**Information Response for MCU Mixed Development
At 49 Macrossan Street, Port Douglas (Planning Act)**

I refer to Council's confirmation notice of 16 October 2017 and the Information Request of 18 October 2017. I am pleased to provide you with the information response for the above described application in accordance with section 13.2(b) of the Development Assessment Rules and Council may now proceed with its assessment of the application.

**DEMOLITION PLAN -
TREE & PALM
RETENTION
STRATEGY**

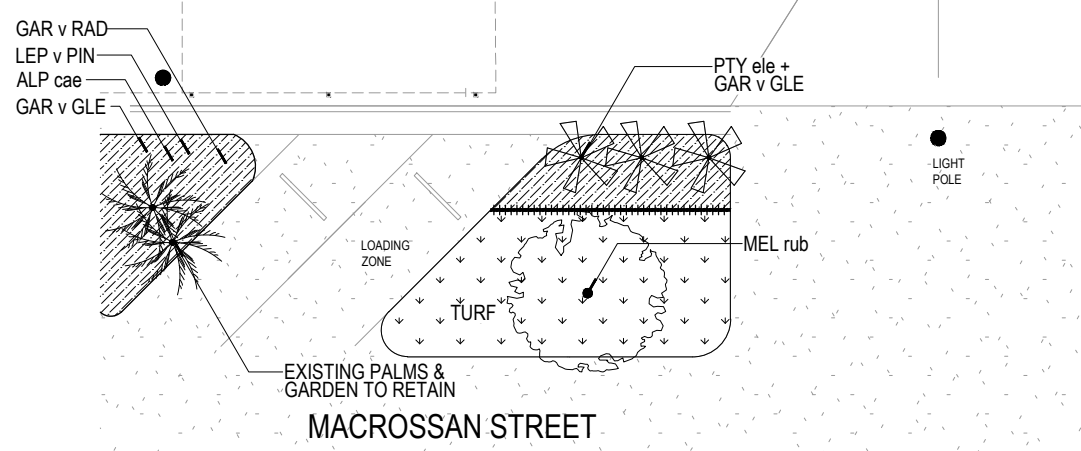
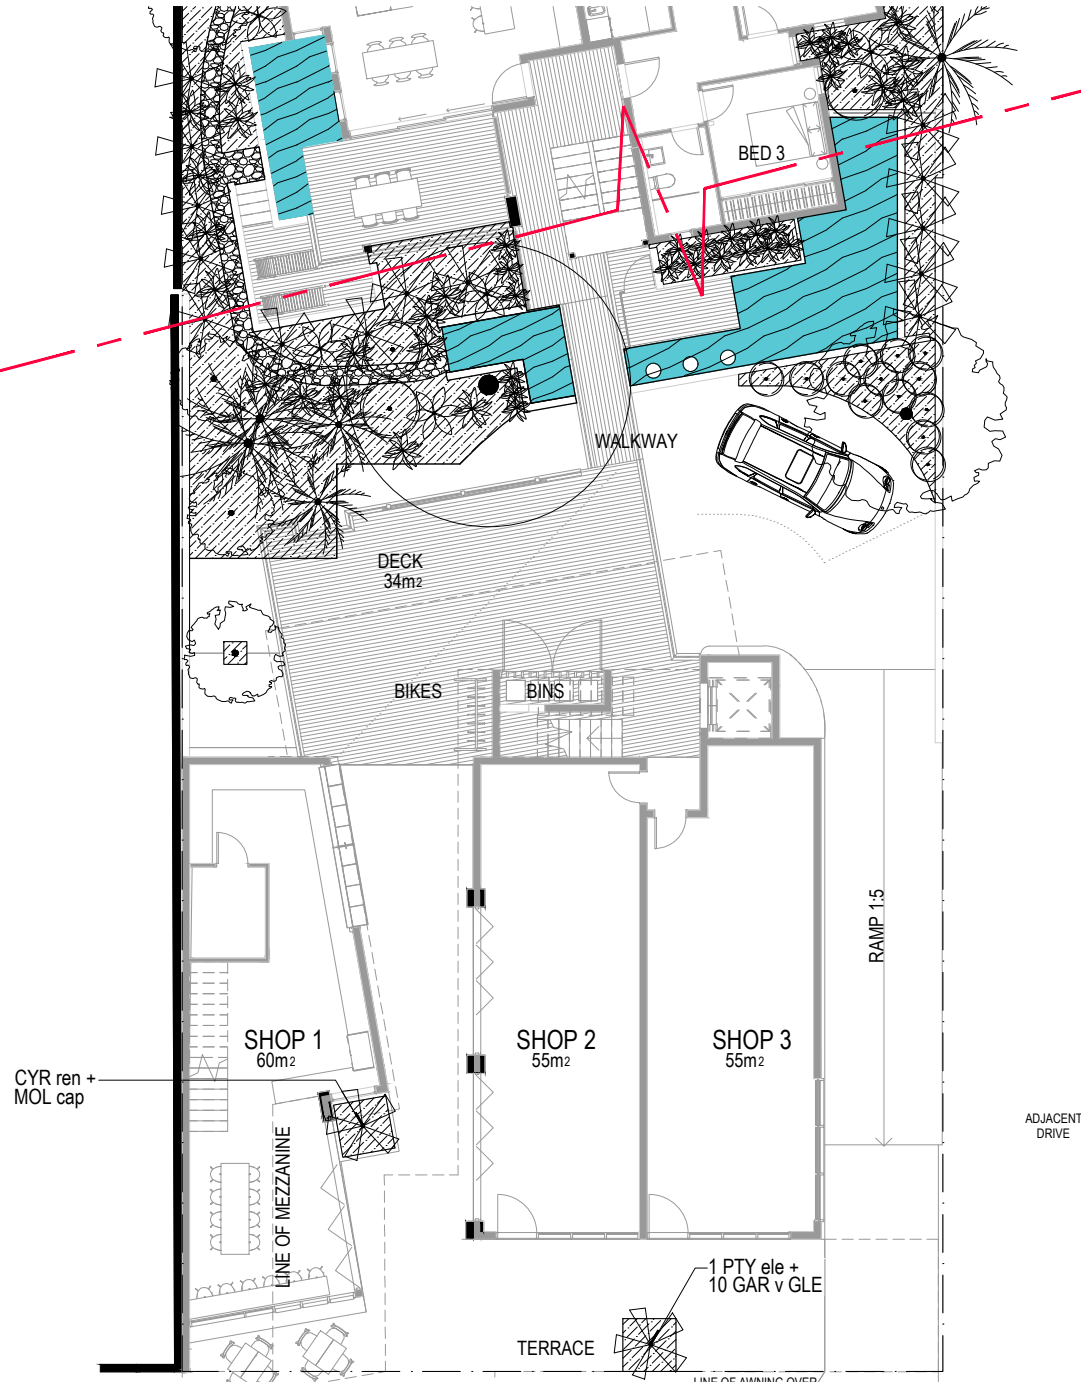
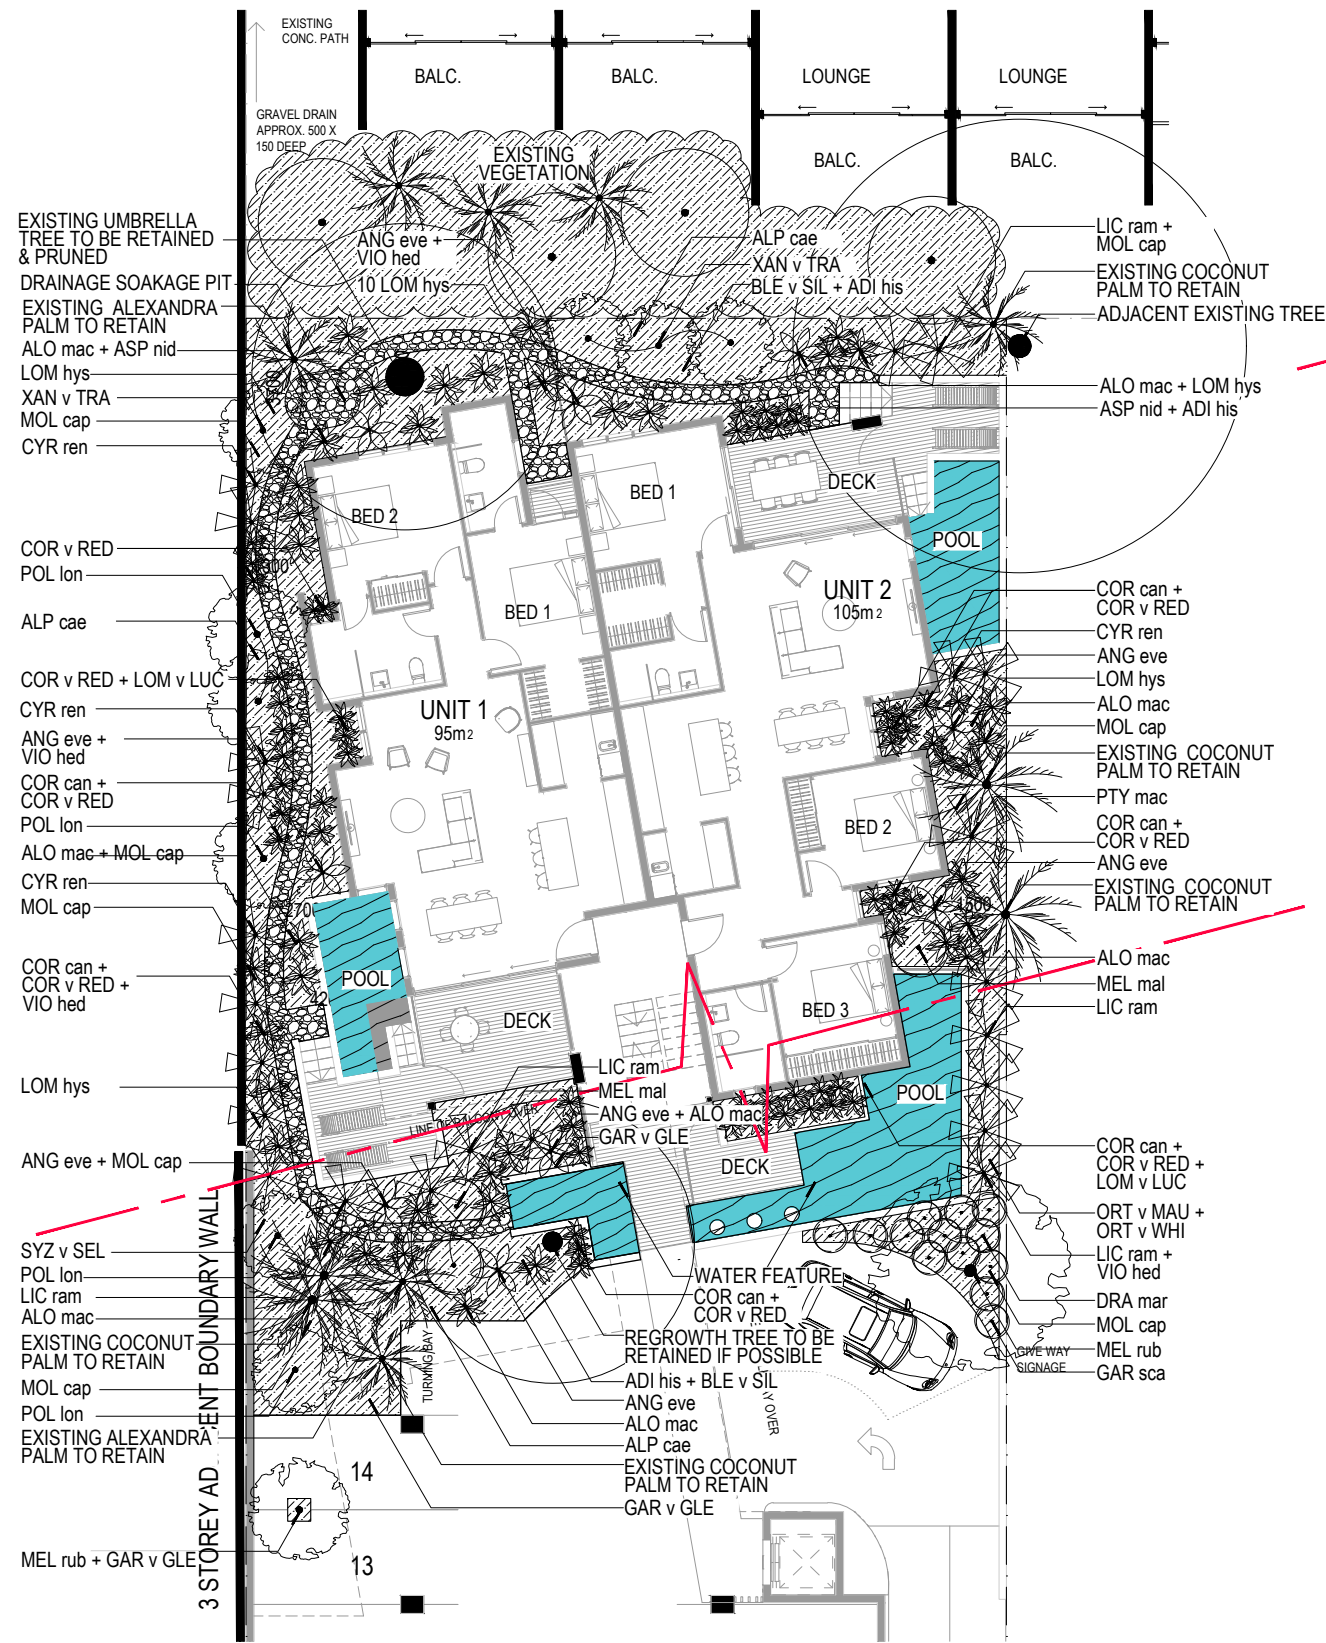
9.2 *Clarify the location of:*

- *the existing Swamp Bloodwood tree on Macrossan Street*
- *the street tree in respect to kerb and channel and vehicle crossovers*
- *the line of awning given the discrepancy between the site plan and the landscape design*

The drawing *Prowse LA 1238 Demolition Plan* shows the location of the Swamp Bloodwood to be removed – it is within the road reserve.
